SUBJECT: MILLSTONE POWER STATION UNITS 2 AND 3 – STAFF ASSESSMENT OF
RESPONSE TO 10 CFR 50.54(f) INFORMATION REQUEST –
FLOOD-CAUSING MECHANISM REEVALUATION (EPID NOS.
000495\05000336\L-2015-JLD-0011 AND 000495\05000423\L-2015-JLD-0012)

STAFF ASSESSMENT BY THE OFFICE OF NUCLEAR REACTOR REGULATION

RELATED TO FLOODING HAZARD REEVALUATION REPORT

MILLSTONE POWER STATION, UNITS 2 AND 3

Figure 3.2-3 Comparison of AWA- and NRC staff- computed storm representative, in-place maximum, and transpositioned maximum dew point values

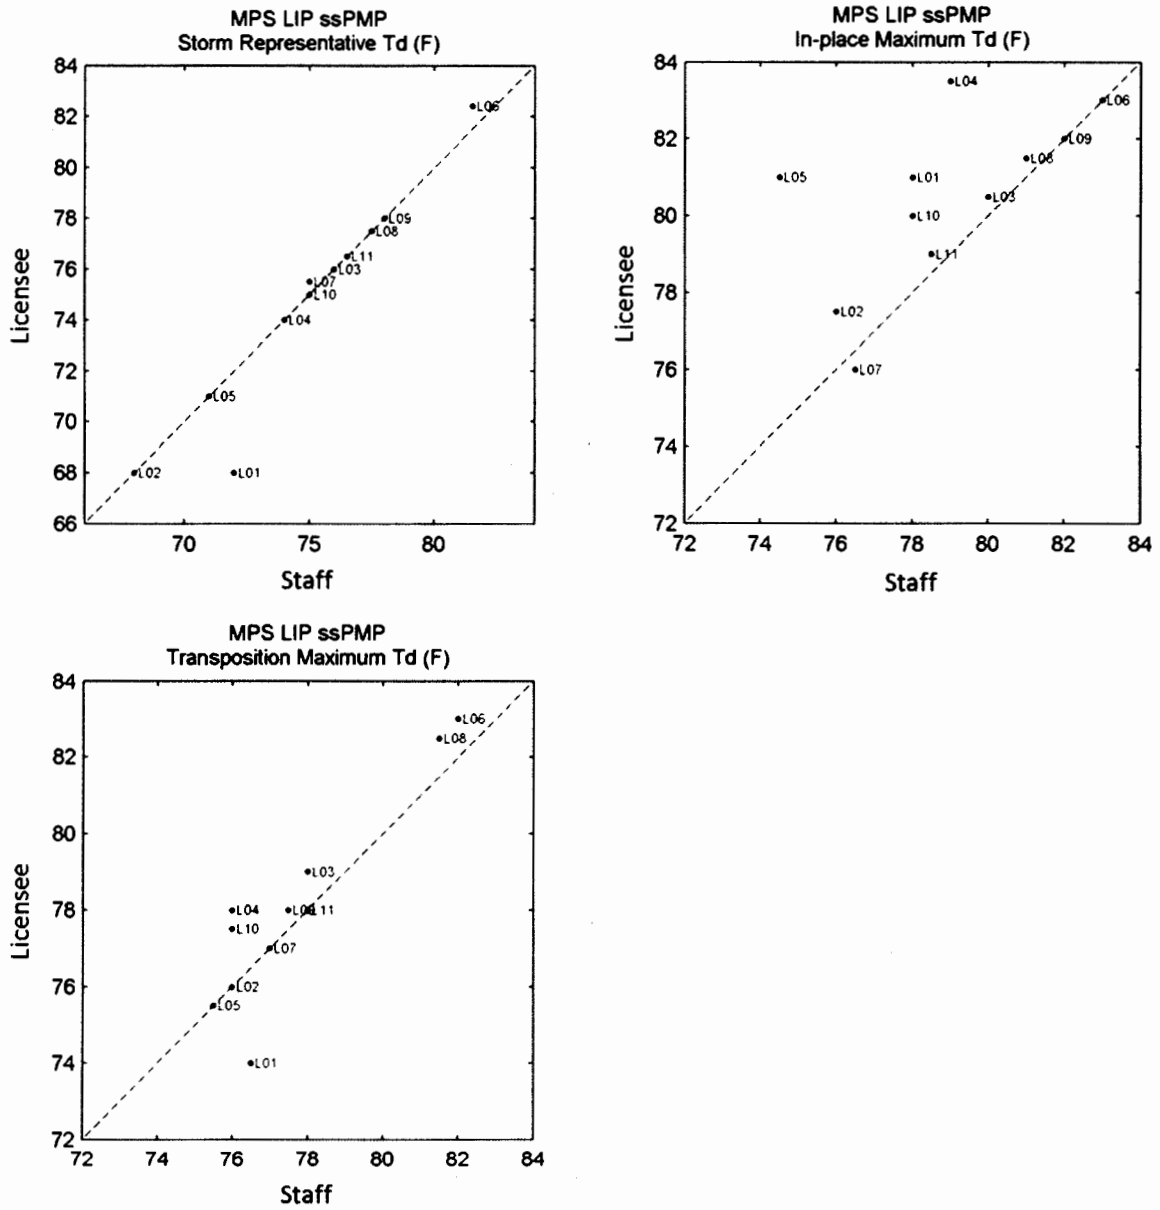
The NRC staff conducted a detailed independent analysis to assess the LIP short list storms. As a part of its assessment, the NRC staff independently computed storm elevation, storm dew point (including storm representative, in-place maximum, and transpositioned maximum dew point values), and total adjustment factors following methodologies similar to those used by the licensee. Regarding the storm elevation data, while staff observed some moderate differences from the values provided by the licensee, the results would not impact the ssPMP calculation. The most notable difference between the NRC staff's and licensee's methodologies relates to the way in which the dew point climatology values (in-place maximum and transpositioned maximum) are determined (Figure 3.2-3). Using the values presented in Figure 3.2-3, the in-place maximization factor and transposition adjustment factor were combined to compute a total adjustment factor (TAF), which is applied to observed DAD data to obtain adjusted DAD data for the ssPMP analysis. The staff-calculated TAF for most storms is not significantly different from the AWA value, ranging from 11 percent lower to 8 percent higher. While the licensee determined dew point climatology values using smoothed maps, the NRC staff relied on its independent gauge-based calculations of climatology values to infer appropriate values.

For some storms, the two approaches resulted in moderately different maximized DAD values, with the staff-calculated values being 3.7 percent to 4.7 percent higher. While the controlling LIP storm (Ewan, NJ) was found to have higher ssPMP values when using staff's results, the differences were driven by small (0.5 to 1.0 degrees Fahrenheit) differences in dew point climatology values at the storm representative and transpositioned locations. Since the licensee's sea-based climatological values were based on NOAA sea surface temperature maps, the NRC staff finds the values used in the licensee's analysis to be reasonable.
